U.S. Department of Energy

Subject: Transmittal of Revisions to the Document Field Services Procedures for the Radiological Excavation Control and Radiological Verification of the Moab Project Site (DOE, May 2005)

Accordingly, enclosed for your review is a revised, simplified process flow chart for the inclusion/exclusion of vicinity properties and accompanying revised text section of the document.

Moab Inclusion/Exclusion Surveys

Decision Tree for Interior and Exterior

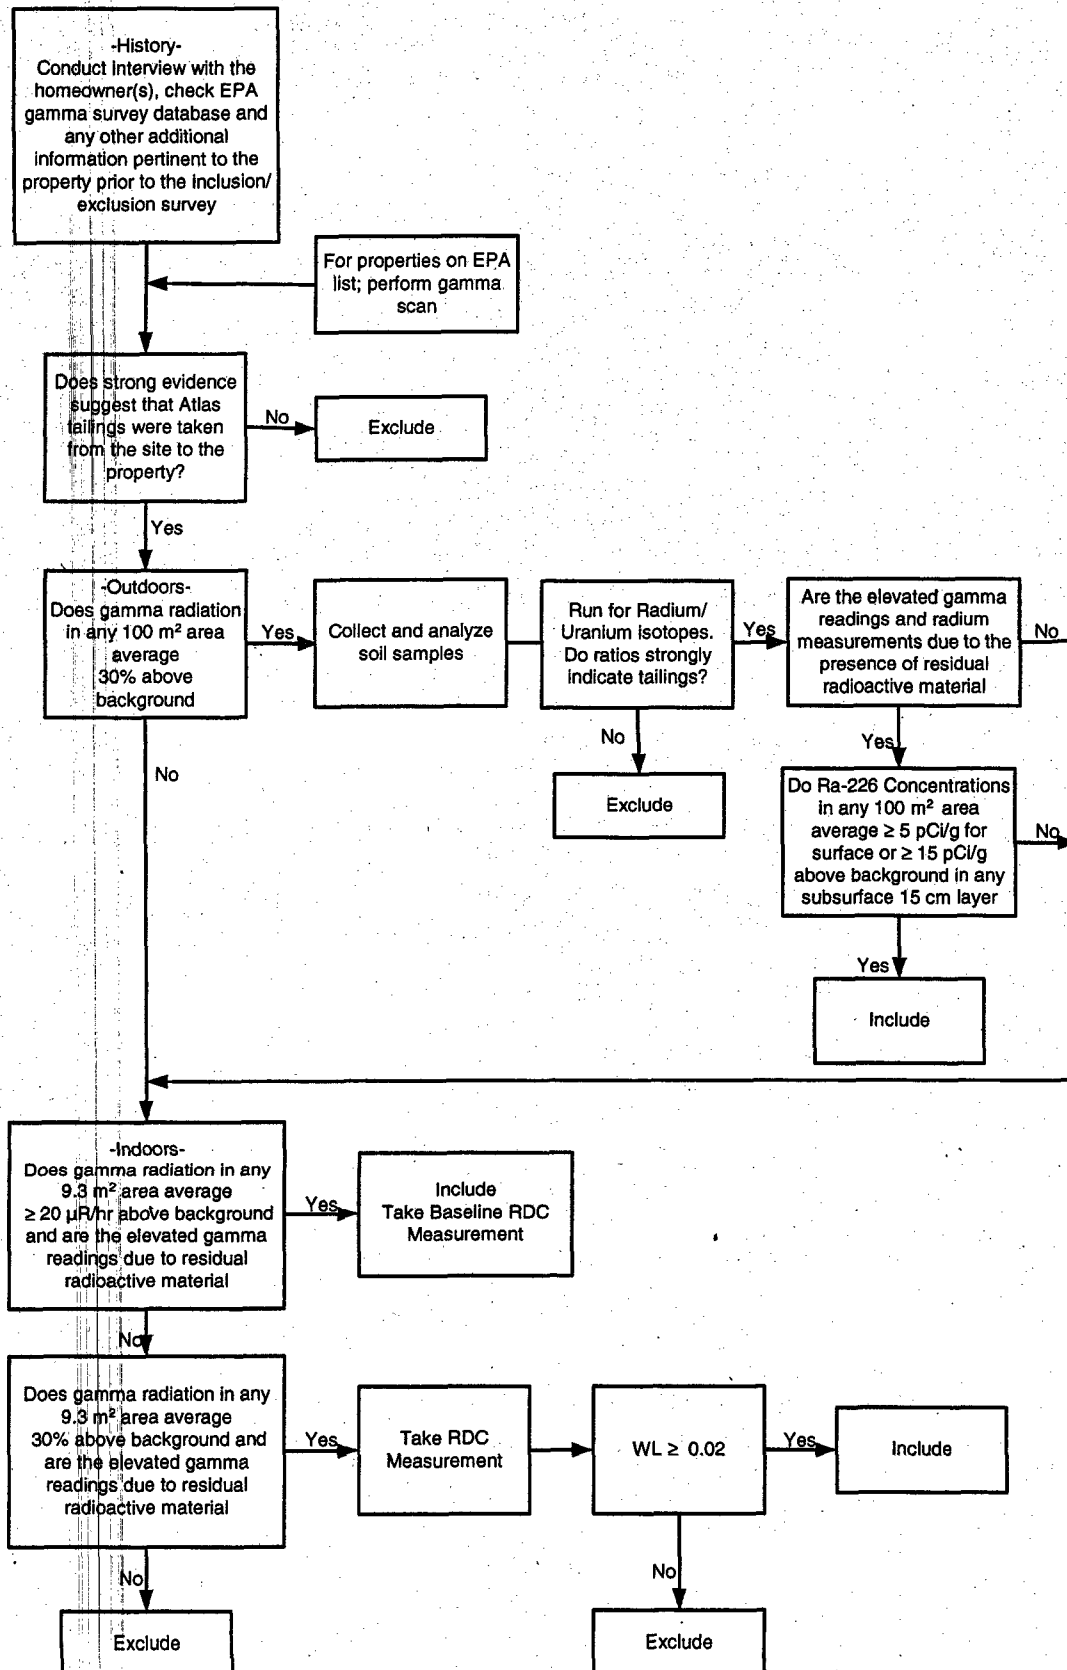
The following page contains the decision tree to be used to determine the basis for recommending inclusion or exclusion. The decision tree will be applied to the data gathered for the exterior, if applicable, then to the data gathered for the interior. The decision tree is designed to provide a logical decision flow through the field data to determine if there are sufficient data to recommend inclusion or exclusion of the property.
